MINNESOTA DEPARTMENT OF TRANSPORTATION

Bridge Office

# Bridge Details Manual Part I

## B-Details

BRIDGE NAMEPLATE  
(FOR NEW BRIDGES)

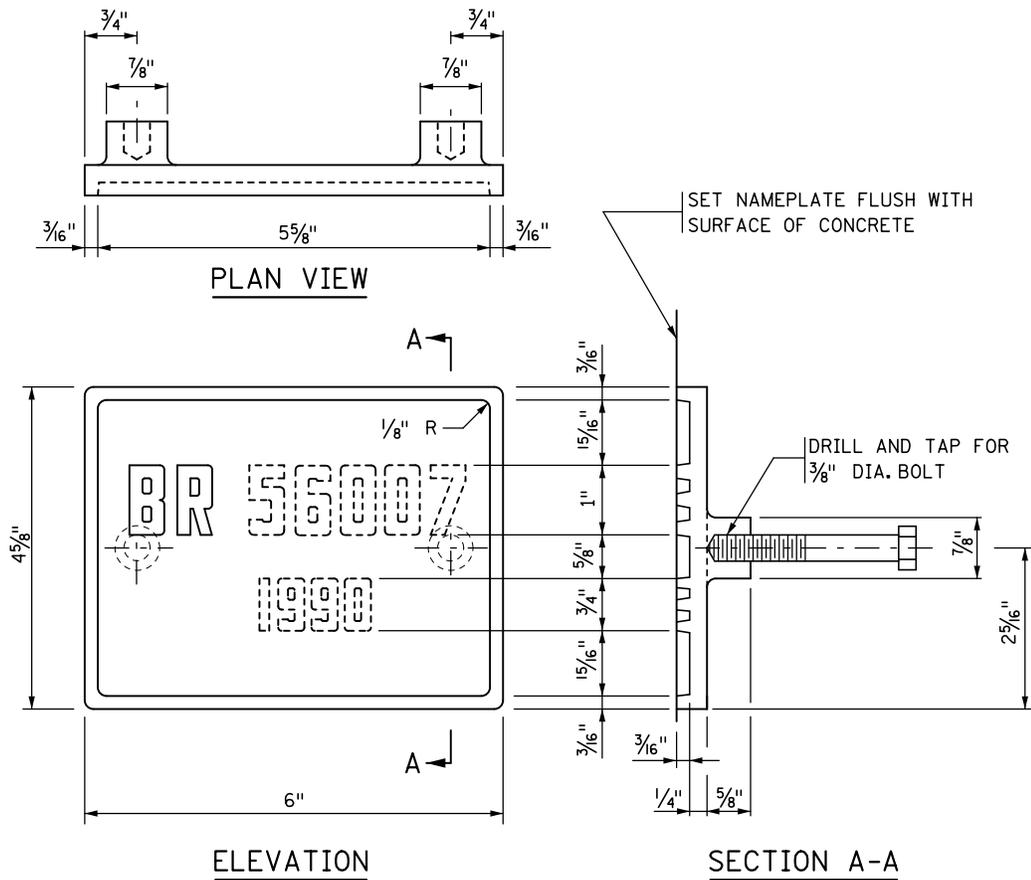
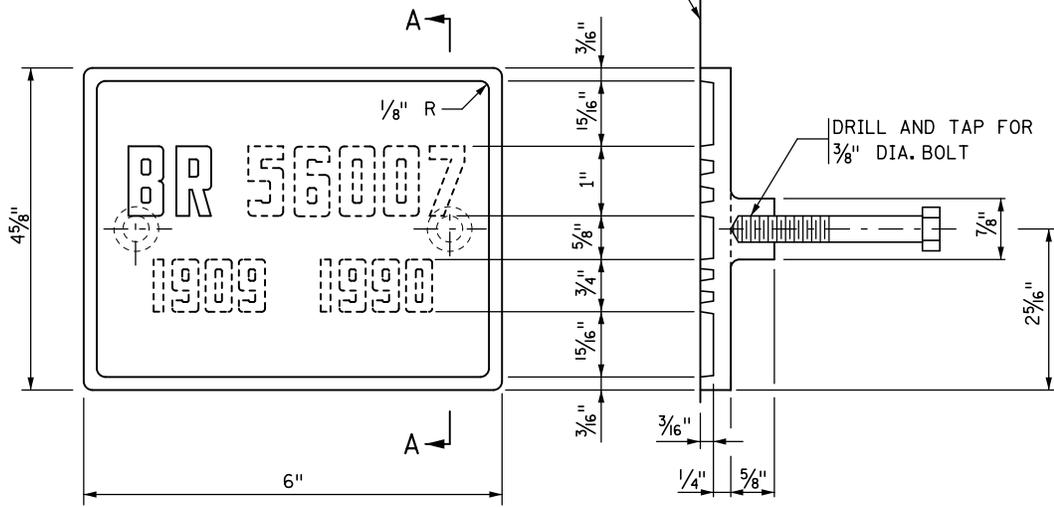
At Section A-A: Changed the note pointing to the Nameplate *From*: Set nameplate flush with surface of concrete except at round columns for piers. *To*: Set nameplate flush with surface of concrete.

Removed from the B-Detail: The “Nameplate Placement” and “Section B-B” details. Also removed the “Mn/DOT” reference within the notes.

**PLAN VIEW - SPLICE BACK-UP RING**  
PILE NOT SHOWN

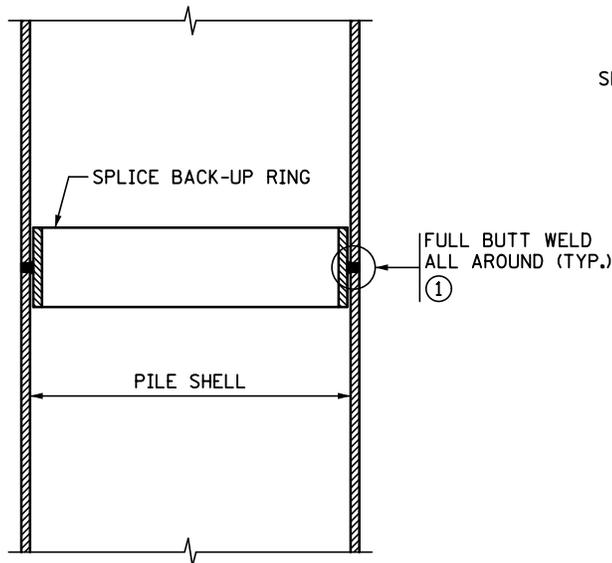
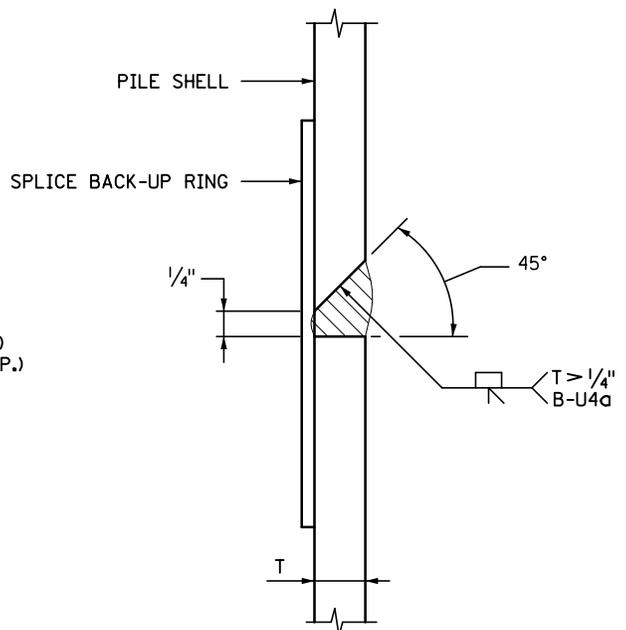
At PLAN VIEW SPLICE:

- Changed the name of the detail *from* PLAN VIEW SPLICE *to* PLAN VIEW-SPLICE BACK-UP RING.
- Changed the rod diameter *from* 1/8" DIA. ROD *to* 1/4" DIA. ROD.

Added DETAIL "A" showing the weld configuration.

- Changed the first note to read: Approved commercial pile splice back-up ring may be used in lieu of the type detailed, provided that 1/4" root is maintained. Back-up ring shall have a tight fit.
- Changed numbered note ①: Changed the 1/2" dimension *to* 1/4" and added See Detail "A".

**TAPERED BEARING PLATE ASSEMBLY**  
 (FOR INTEGRAL ABUTMENTS OR PIERS WITH CONTINUITY DIAPHRAGMS)

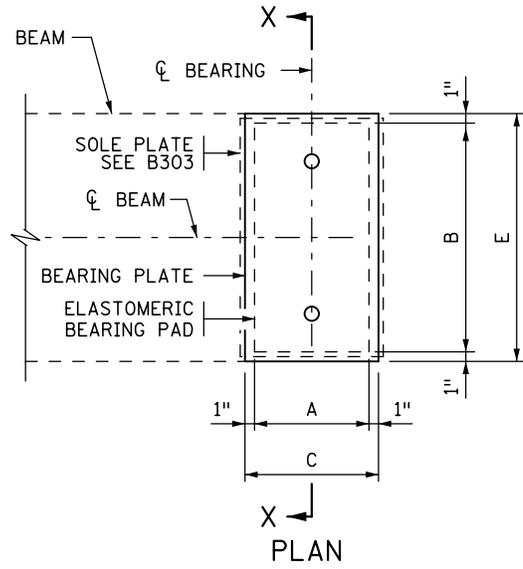
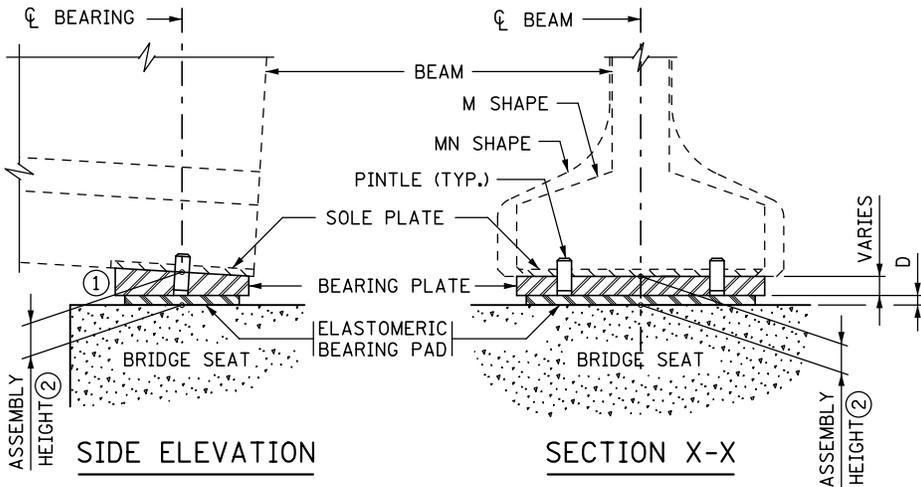
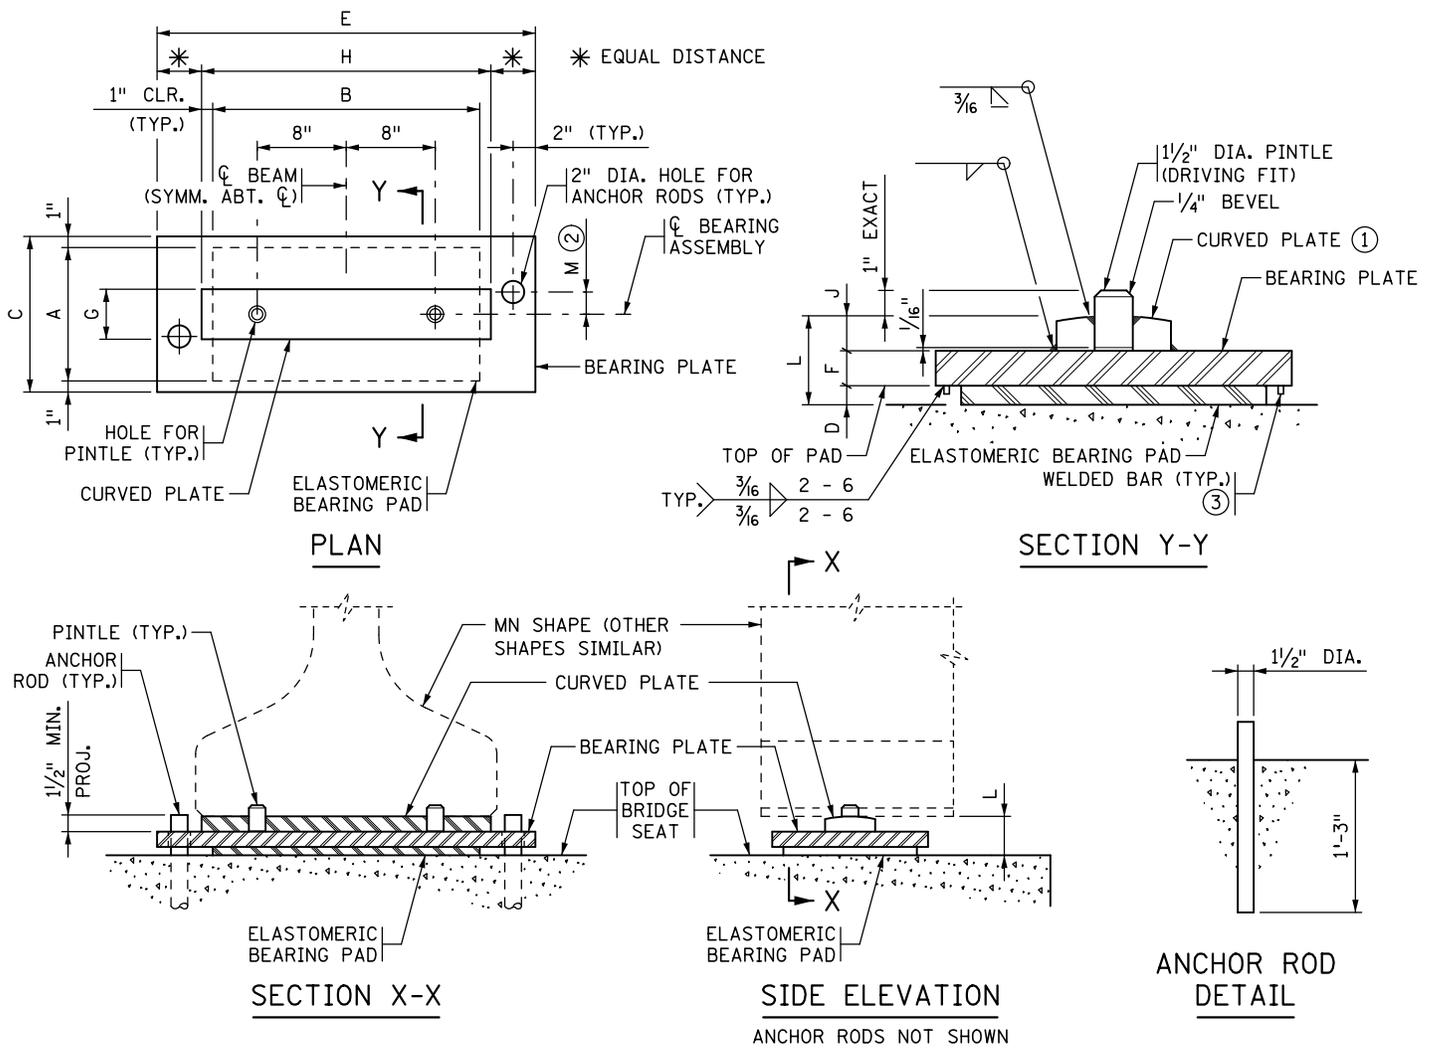
At BEARING PLATE DETAIL:

- Changed from welded “keeper” studs” to a welded “keeper” bar.
- Added the 3/16” fillet weld symbol to the welded bar on the lower right side of the detail.
- Changed the “Welded Stud (Typ.) ④” to “Welded Bar (Typ.) ④”
- Removed the 1/2” recess dimension from the top left of the bearing plate.

STATE OF MINNESOTA  
 DEPARTMENT OF TRANSPORTATION  
**POT BEARING ASSEMBLY**  
 (STEEL BEAMS)  
 (NON-GUIDED EXPANSION)

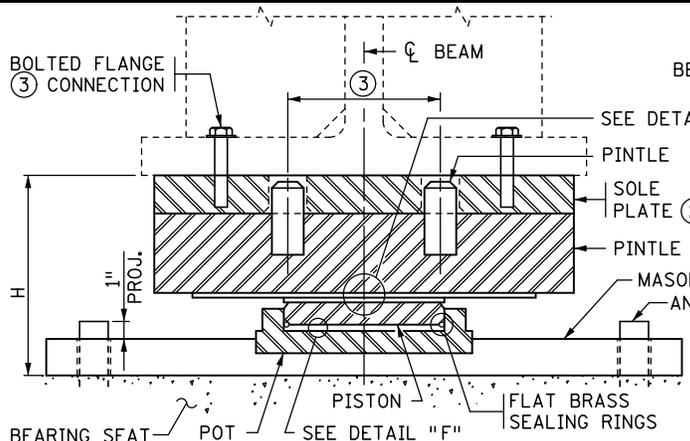
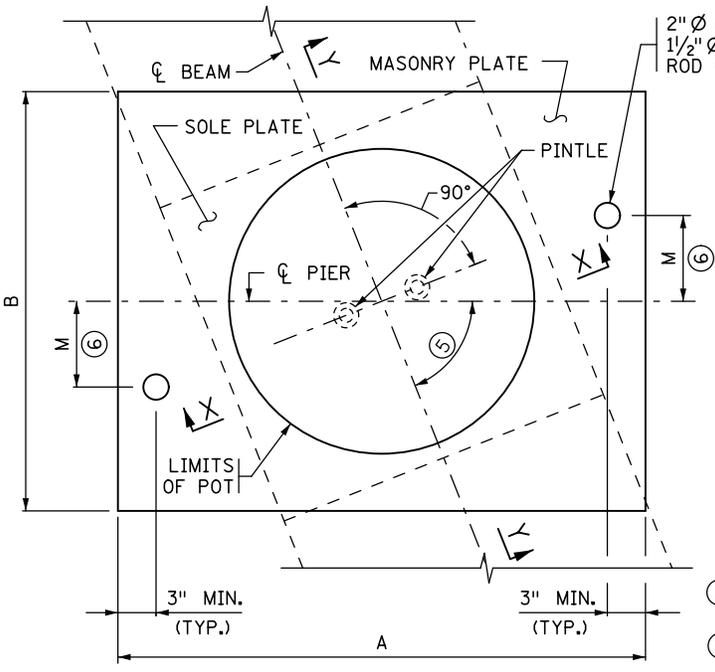
Revised detail and Renamed from: “PLAN” to “DETAIL AT MASONRY PLATE”

Revised and Renamed Table from: “BEARING ASSEMBLY DIMENSIONS” to “BEARING ASSEMBLY TABLE” with additional new columns, sub-columns and numbered notes.

At B-DETAIL TITLE – Change title name from: “POT TYPE BEARING ASSEMBLY” to “POT BEARING ASSEMBLY”

- (3<sup>rd</sup> sentence) Removed the words “pintle plate” from the sentence.
- Replace note ① with the following text – “Factored live load (LL) rotation or 0.02 radians whichever is greater.”

- Changed note ③ to read – “Pot bearing manufacturer to determine the final dimensions and number of all bearing components including piston, pot, masonry plate, sole plate, threaded fasteners, bolted flange connections, pintles and overall height. Minimum pintle size is 1½” diameter.” Also added ③ to the MASONRY PLATE location in the BEARING ASSEMBLY TABLE.

- Changed note ④ to read – “Horizontal resistance shall be a minimum of 20% of the vertical applied load unless stated otherwise.” Also added ④ to DESIGN LOAD (KIPS) location in the BEARING ASSEMBLY TABLE.

- Added note ⑤ - “See framing plan.” Also added ⑤ to angle dimension at the DETAIL AT MASONRY PLATE.
- Added note ⑥ - “Two 1½” diameter anchor rods have a maximum resistance of 95 kips. Designer shall increase diameter, number of rods or both when needed.” Also added ⑥ to ANCHOR ROD DETAIL and anchor rod note at the DETAIL AT MASONRY PLATE.

- Added note ⑦ - “+” Denotes offset as shown.” “-” Denotes offset opposite as shown.” Also added ⑦ to dimension “M” showing the offset from centerline pier at the DETAIL AT MASONRY PLATE and ANCHOR ROD OFFSET +/- location in the BEARING ASSEMBLY TABLE.

STATE OF MINNESOTA  
DEPARTMENT OF TRANSPORTATION  
**POT BEARING ASSEMBLY**  
(STEEL BEAMS)  
(FIXED)

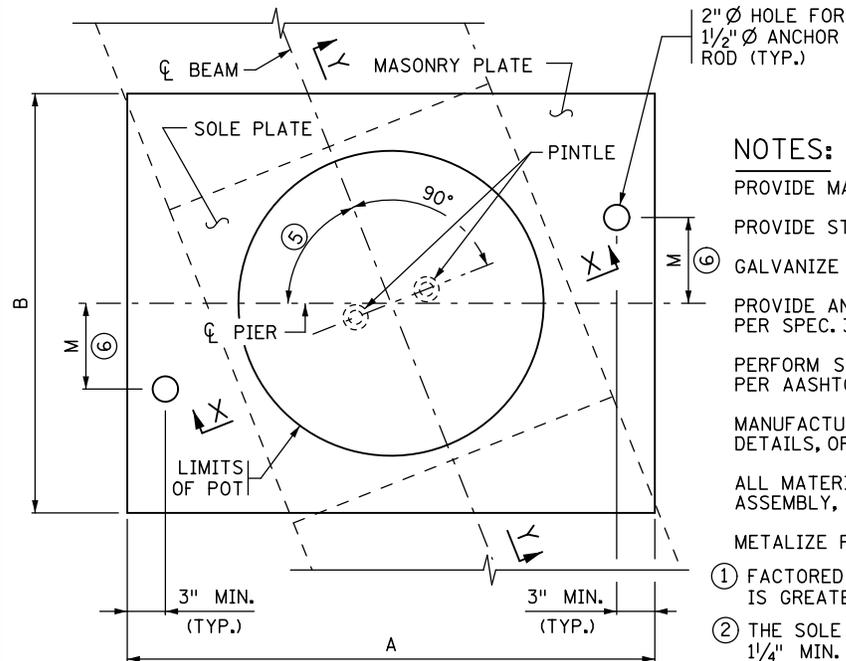
Revised detail and Renamed from: “PLAN” to “DETAIL AT MASONRY PLATE”

Revised and Renamed Table from: “BEARING ASSEMBLY DIMENSIONS” to “BEARING ASSEMBLY TABLE” with additional new columns, sub-columns and numbered notes.

At B-DETAIL TITLE – Change title name from: “POT TYPE BEARING ASSEMBLY” to “POT BEARING ASSEMBLY”

- (3<sup>rd</sup> sentence) Removed the words “pintle plate” from the sentence.
- Replace note ① with the following text – “Factored live load (LL) rotation or 0.02 radians whichever is greater.”

- Changed note ③ to read – “Pot bearing manufacturer to determine the final dimensions and number of all bearing components including piston, pot, masonry plate, sole plate, threaded fasteners, bolted flange connections, pintles and overall height. Minimum pintle size is 1½” diameter.” Also added ③ to the MASONRY PLATE location in the BEARING ASSEMBLY TABLE.

- Changed note ④ to read – “Horizontal resistance shall be a minimum of 20% of the vertical applied load unless stated otherwise.” Also added ④ to DESIGN LOAD (KIPS) location in the BEARING ASSEMBLY TABLE.

- Added note ⑤ - “See framing plan.” Also added ⑤ to angle dimension at the DETAIL AT MASONRY PLATE.
- Added note ⑥ - “Two 1½” diameter anchor rods have a maximum resistance of 95 kips. Designer shall increase diameter, number of rods or both when needed.” Also added ⑥ to ANCHOR ROD DETAIL and anchor rod note at the DETAIL AT MASONRY PLATE.

- Added note ⑦ - ““+” Denotes offset as shown.” ““-” Denotes offset opposite as shown.” Also added ⑦ to dimension “M” showing the offset from centerline pier at the DETAIL AT MASONRY PLATE and at ANCHOR ROD OFFSET +/- location in the BEARING ASSEMBLY TABLE.
